Addendum No. 3

September 10, 2021

Project: San Fernando Regional Park Infiltration Project

**Attachment 4: Revisions to Diversion Pipe Plan and
Profile from Glenoaks Boulevard**

40

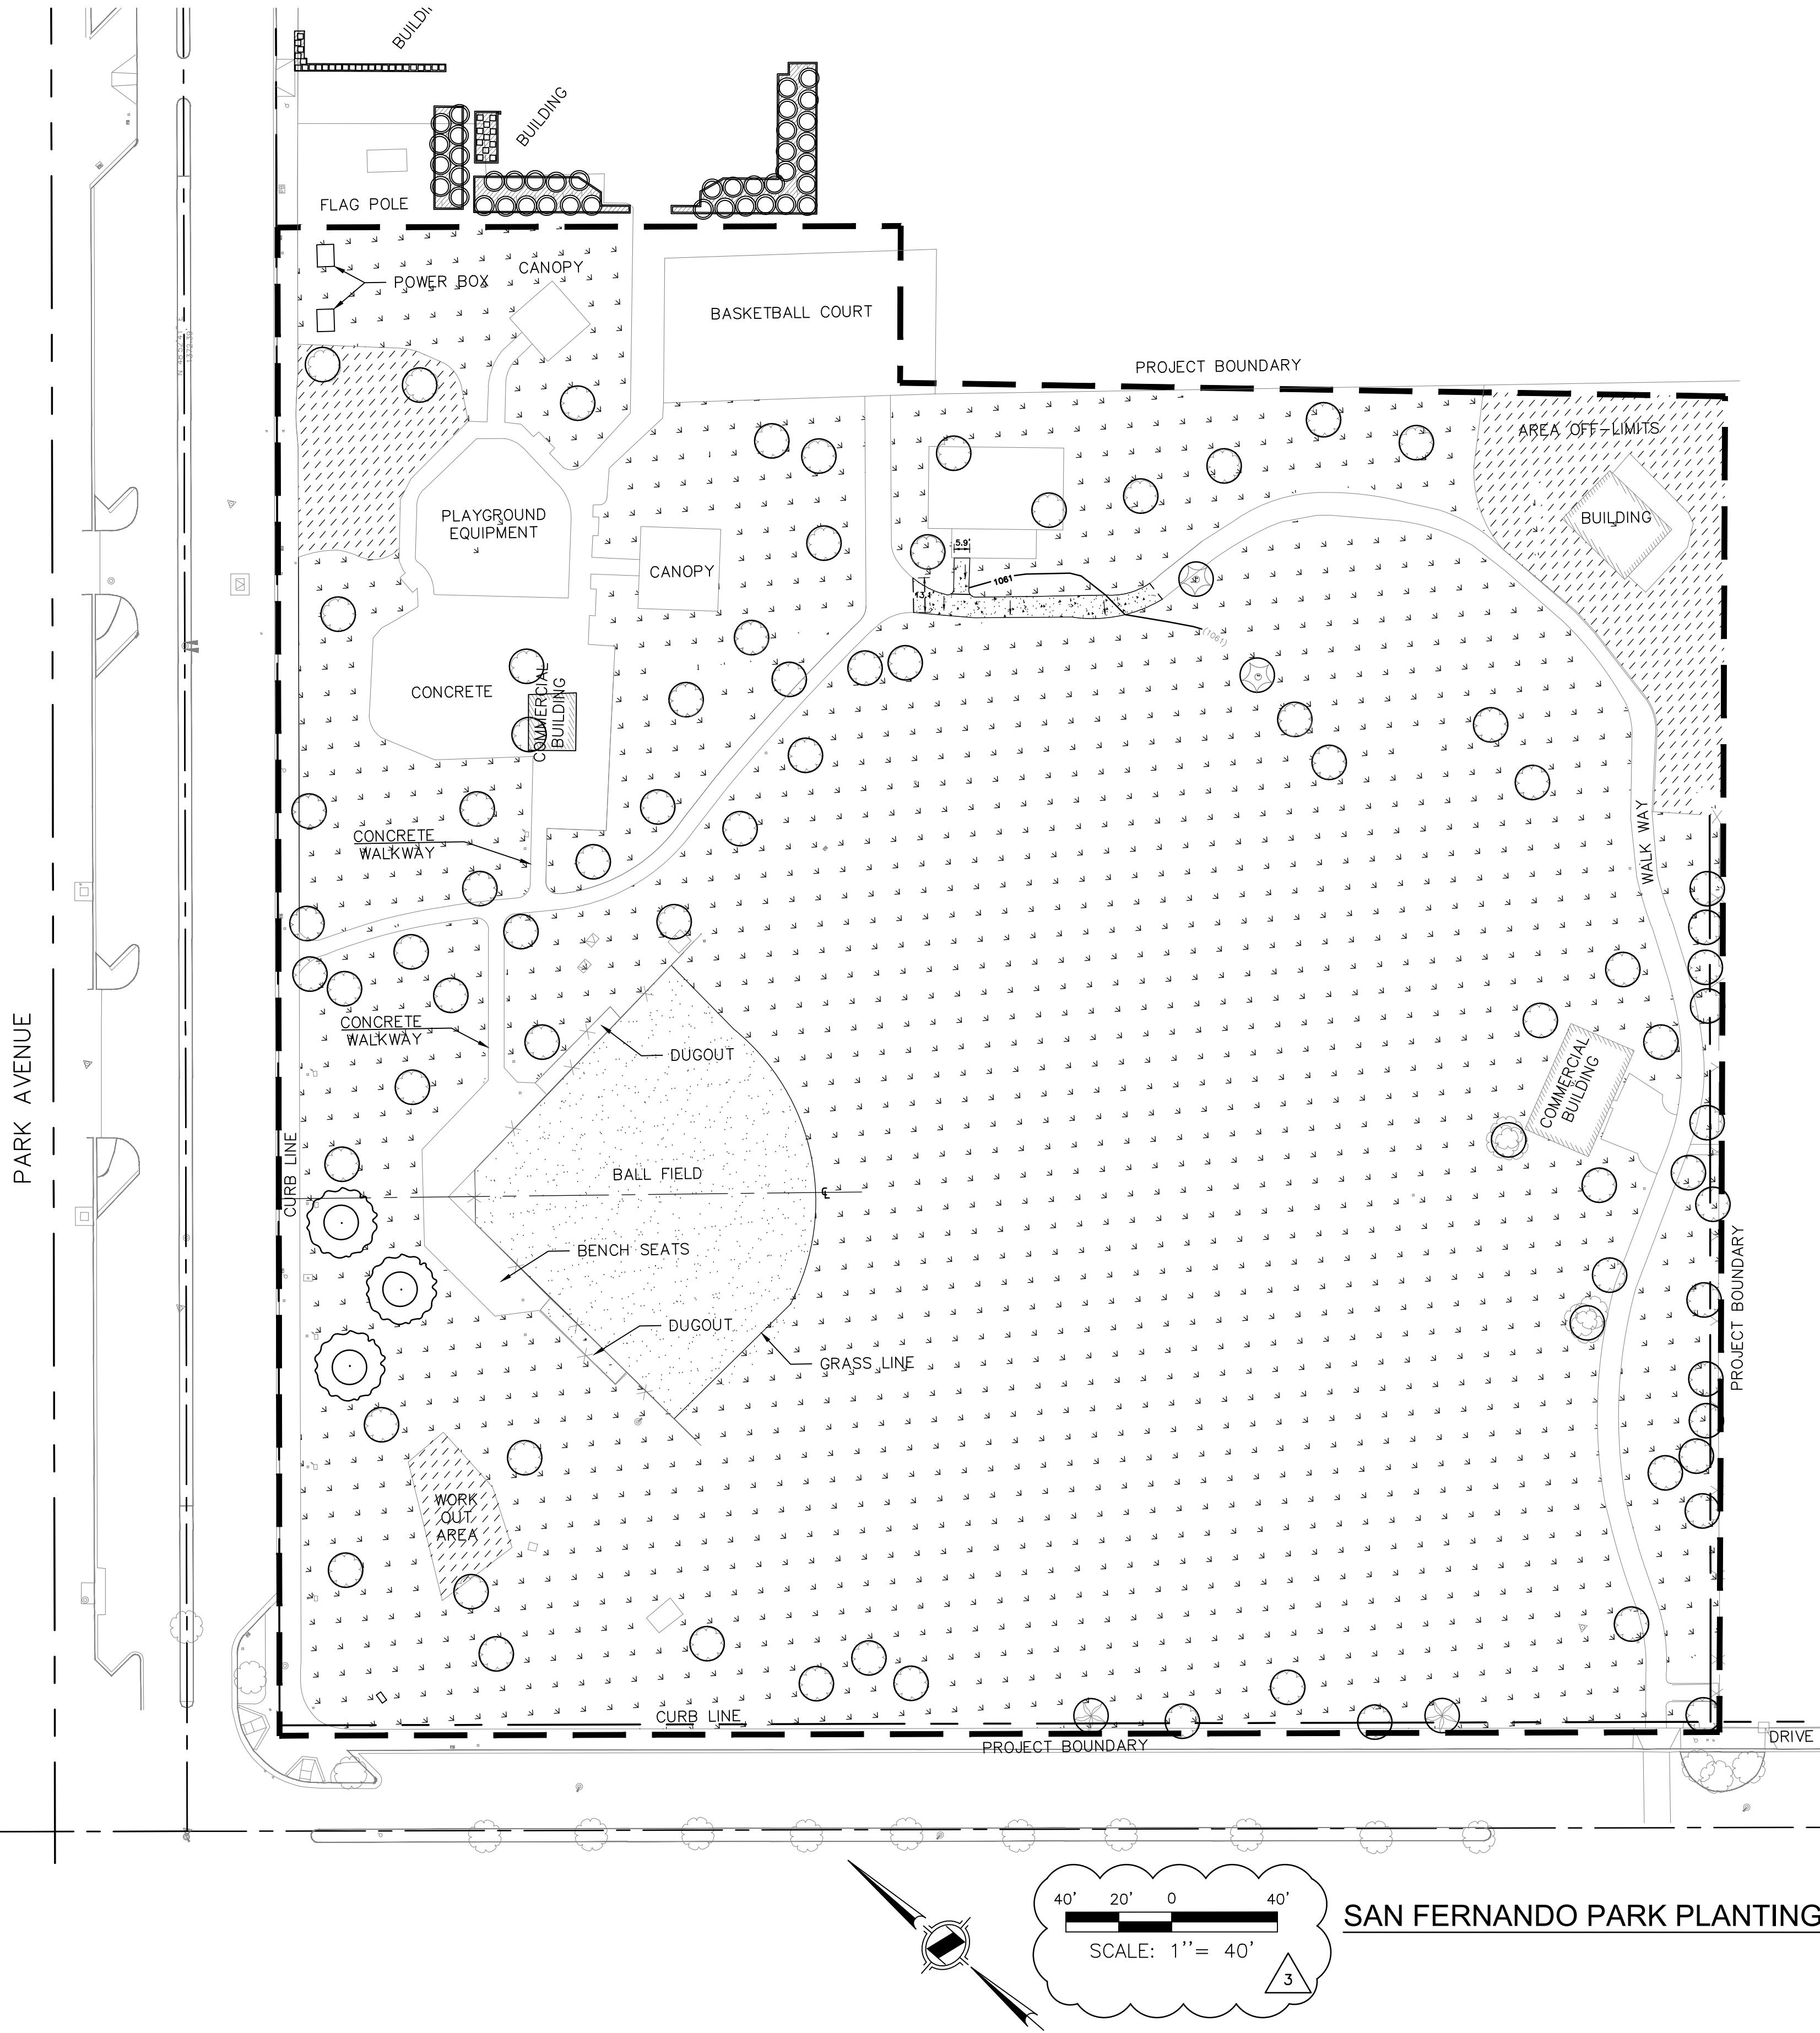
Question #51: The drawing LS-02 scale is incorrect. Please issue correct drawing scale.

REV.	DATE	BY	DESCRIPTION	APP'D
3	9/10/21	TT	REVISED SCALE

Answer #51: Revised landscape sheets are attached to this addendum as Attachment 5.
